**CITY OF KELOWNA
MEMORANDUM**

DATE: February 12, 2009
TO: City Manager
FROM: Community Sustainability Division
APPLICATION NO. Z09-0004 **APPLICANT:** Peter Teschner
AT: 1386 Tanemura Cres. **OWNER:** Cherry Lane Homes Ltd.,
Inc. No. BC0668936

PURPOSE: TO REZONE FROM THE RU1 – LARGE LOT HOUSING ZONE TO THE RU1(S) - LARGE LOT HOUSING WITH SECONDARY SUITE ZONE TO CONSTRUCT A SECONDARY SUITE WITHIN A PRINCIPAL DWELLING.

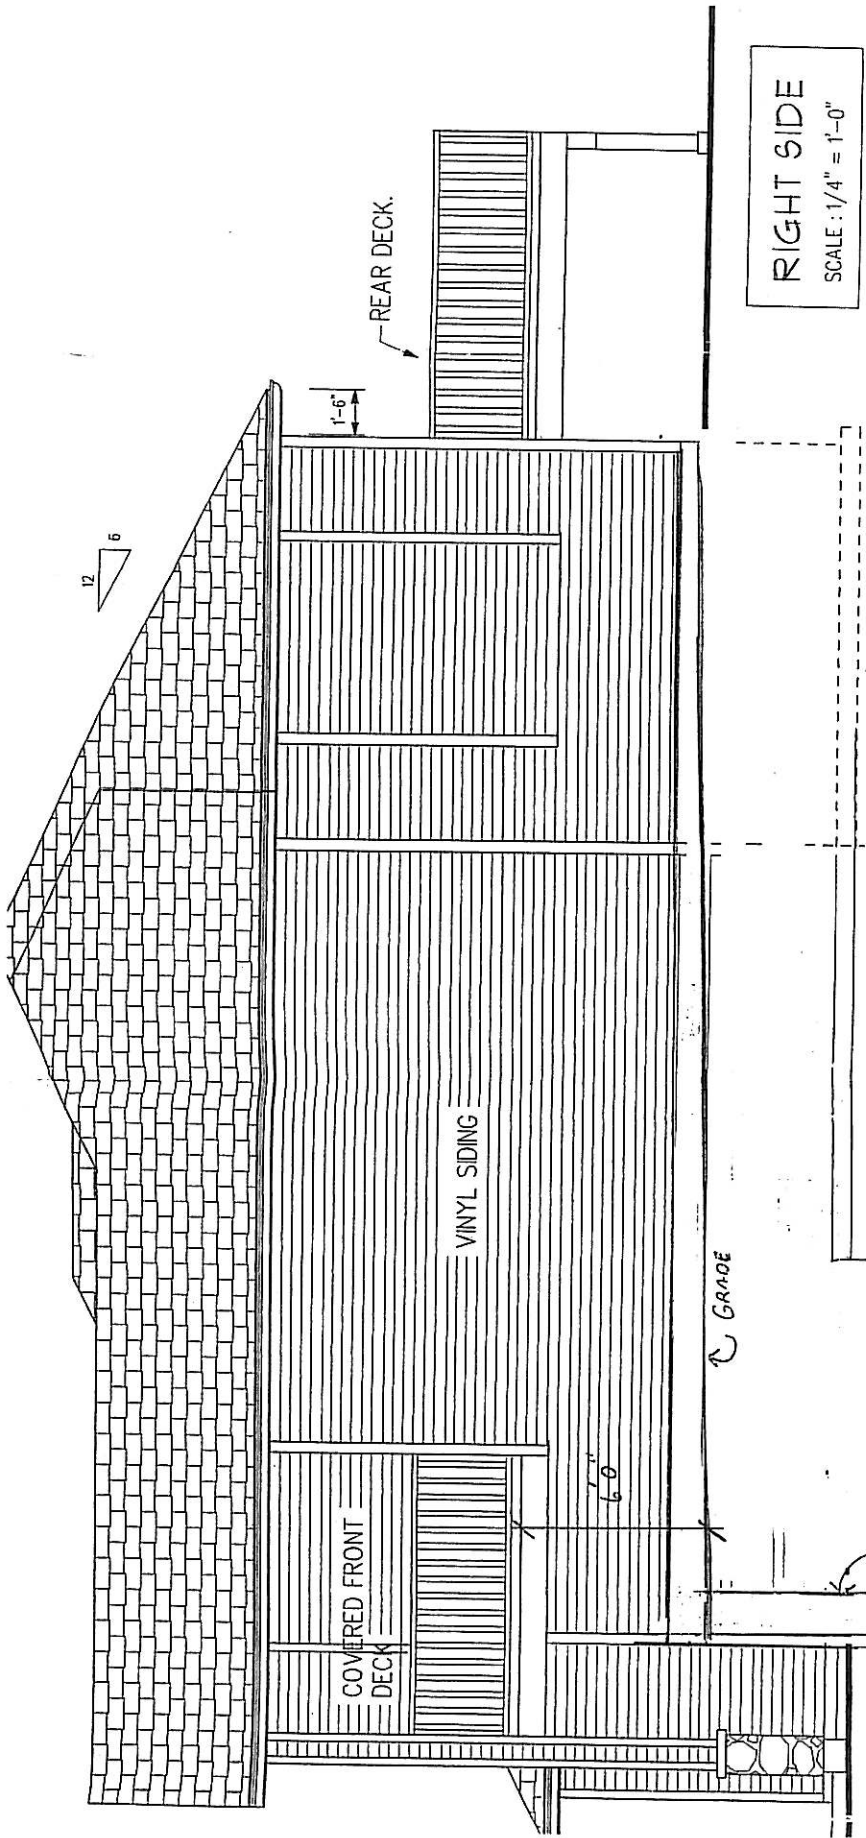
RETAINING WALLS OVER 1.2M
 ARE NOT PERMITTED. ENSURE
 COMPLIANCE TO ZONING BYLAW 8000.

RIGHT SIDE
SCALE: 1/4" = 1'-0"

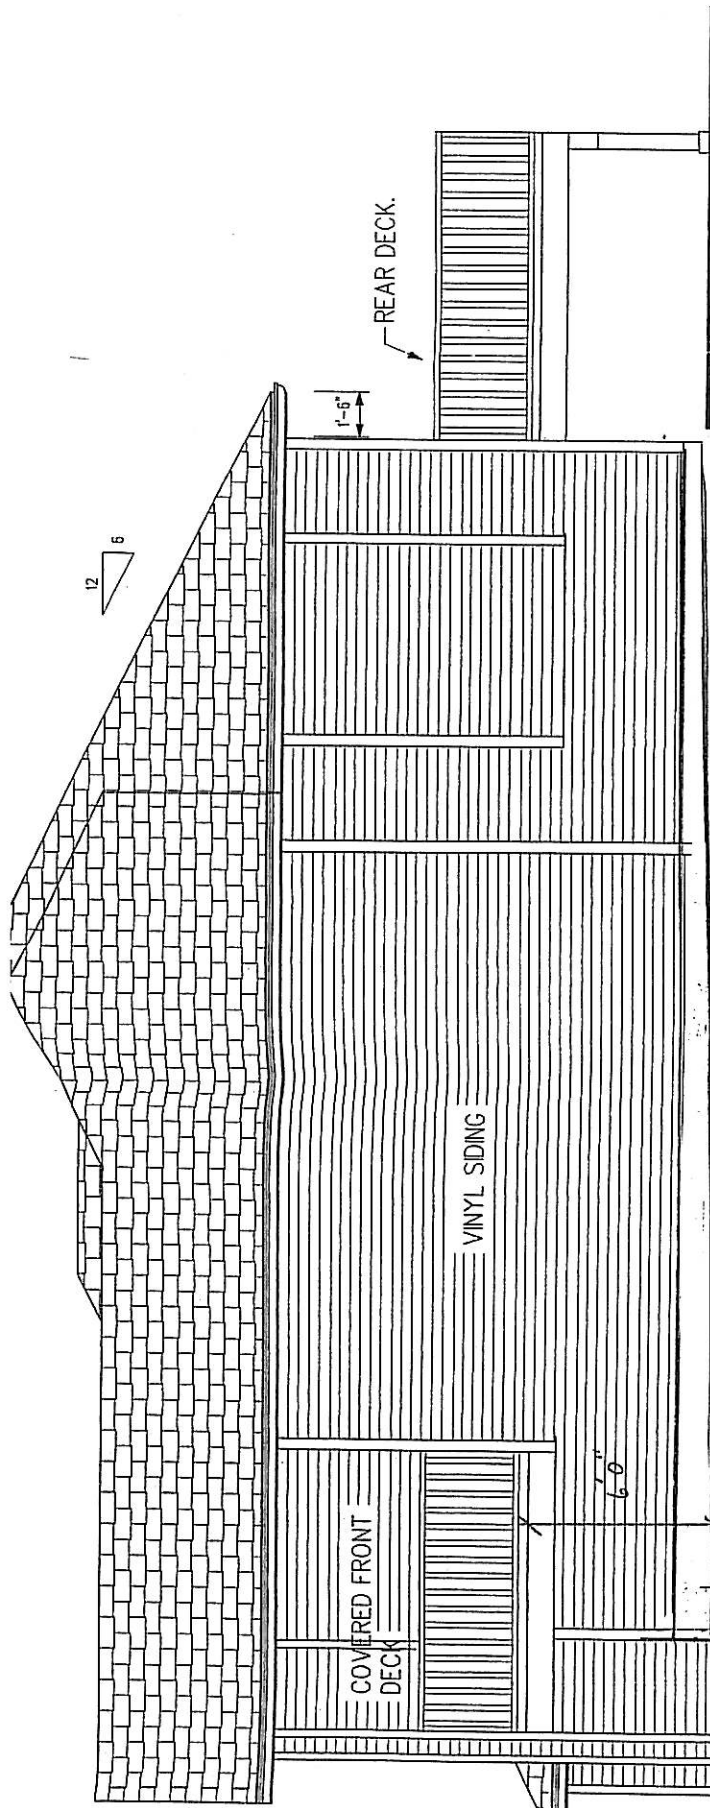
RETAINING WALLS OVER 1.2m
 ARE NOT PERMITTED. ENSURE
 COMPLIANCE TO ZONING BYLAW 8000
